GREEN INFRASTRUCTURE

23178
Proposed Development
at Lucan

July 2023

PROPOSED GREEN
INFRASTRUCTURE
STRATEGY

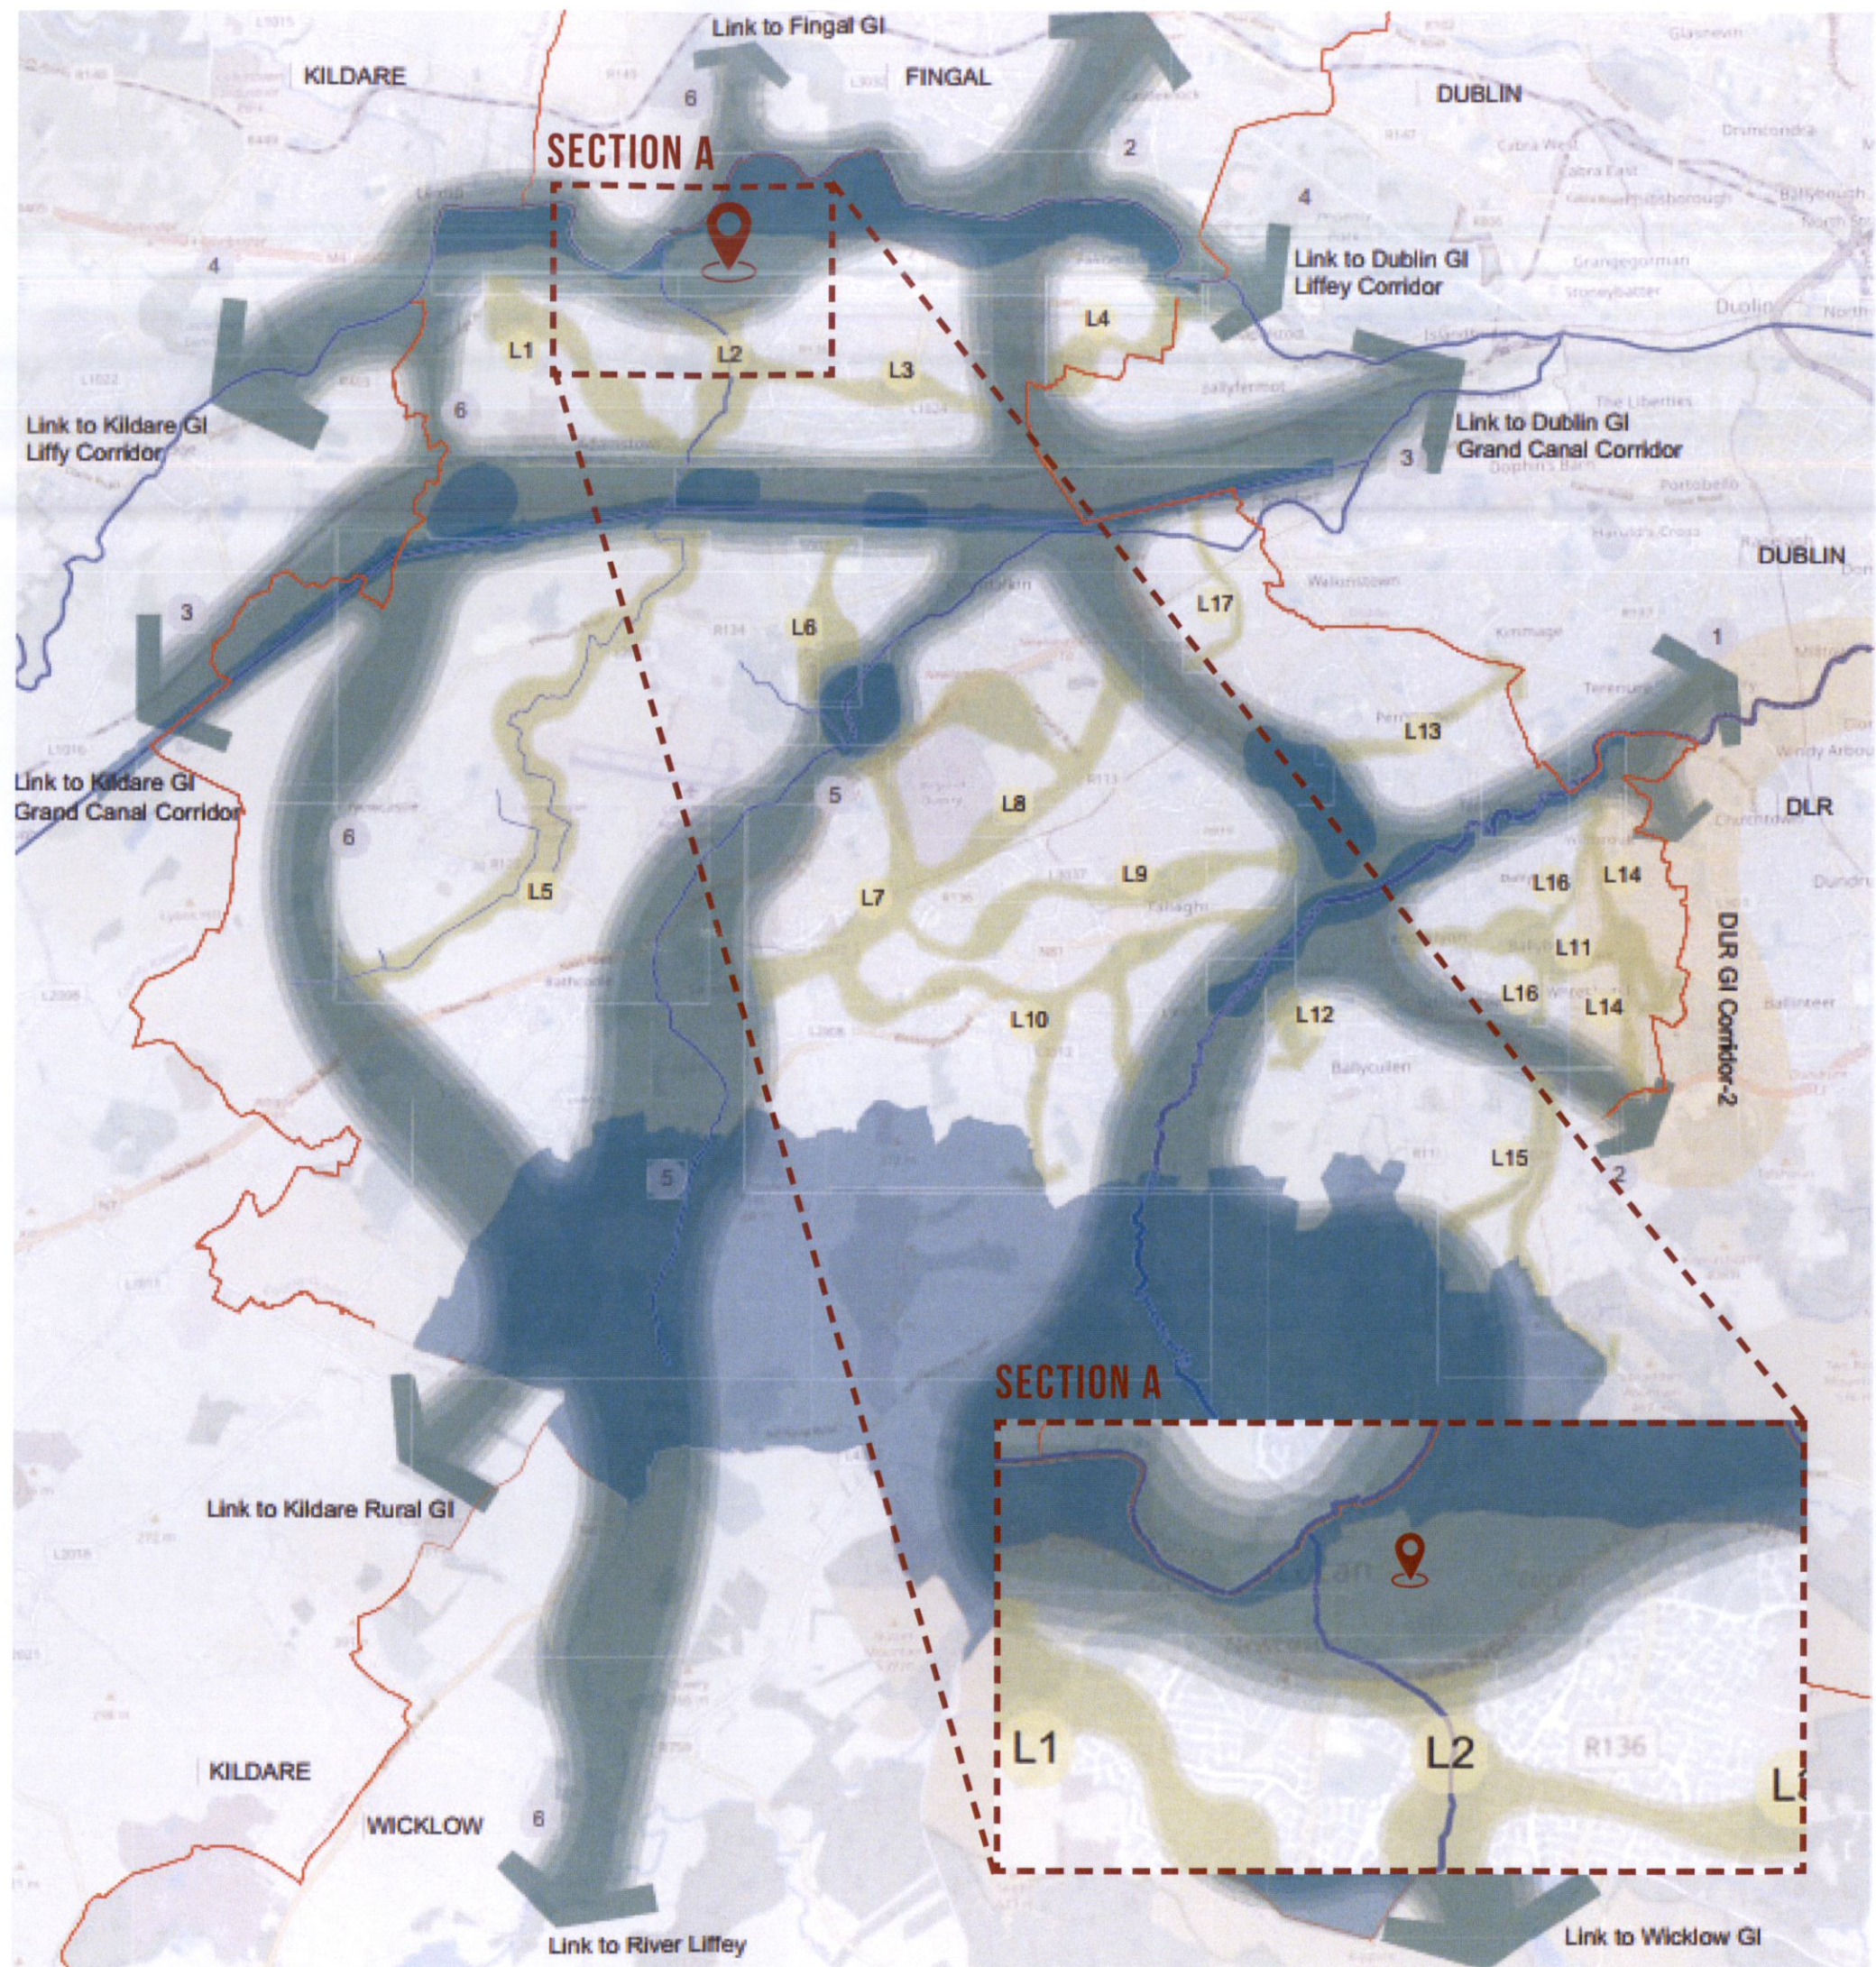
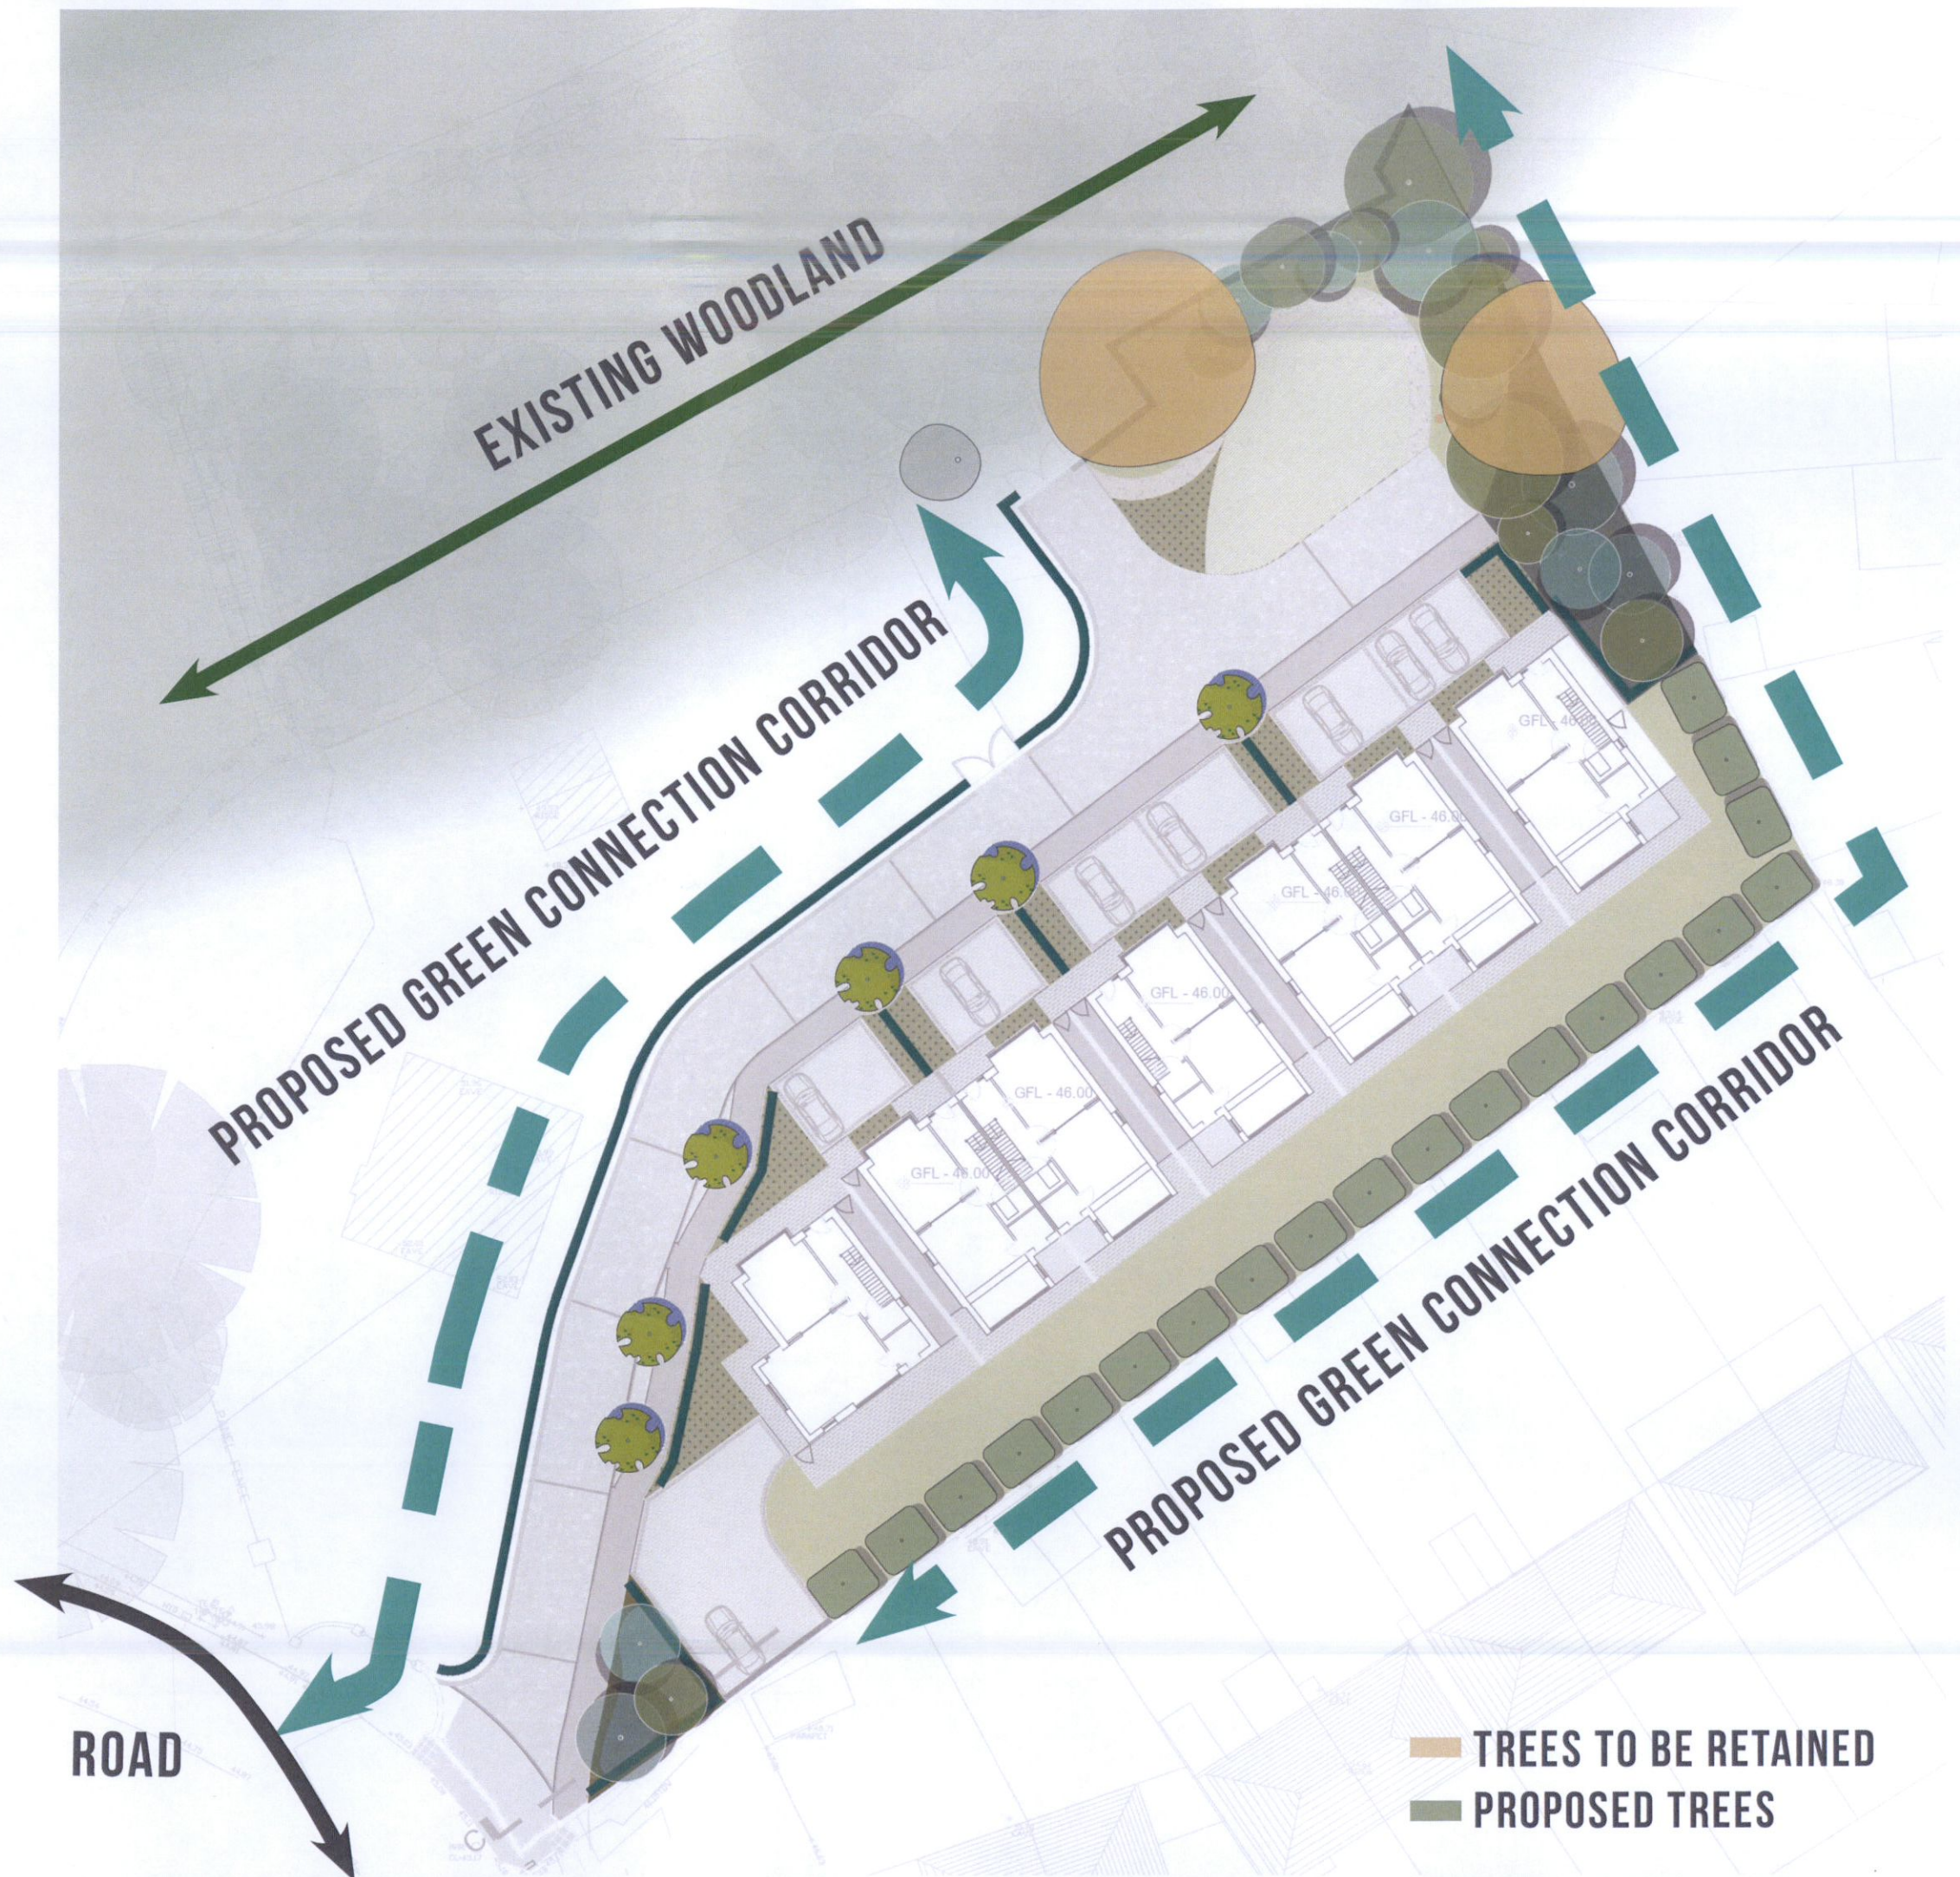
(i) It is noted that the Applicant is proposing to remove virtually all of the existing Green Infrastructure that is currently on the site. This would result in the fragmentation of the Green Infrastructure Network and would be unacceptable to the Planning Authority. In this regard, the Applicant is requested to provide a Green Infra-structure Plan (to be coordinated with the revised Landscape Plan, Planting Plan, Drainage Plan and SuDS Plan) that includes objectives to protect or restore existing on-site GI assets, provides for connection to local or primary GI corridors or includes elements which allow the site to act as a local steppingstone.

The strategic location of the site within the Liffey Valley Green Infrastructure Corridor emphasises the importance of seamlessly aligning our development with this broader ecological framework. To achieve this, our proposed measures fully adhere to the principles and objectives set by both local and regional Green Infrastructure initiatives.

Recognising the findings of the tree survey, we agree with your assessment that a significant portion of the existing trees have limited quality and value, and a short lifespan. Therefore, keeping them would

not be practical. Our revised landscape plan takes this into careful consideration and offers a solution by introducing screening trees along the southern boundary at the back of the gardens. Additionally, we are firmly committed to re-establishing a Coniferous Woodland along the eastern boundary, a commitment that greatly enhances the Green Infrastructure Network within the site.
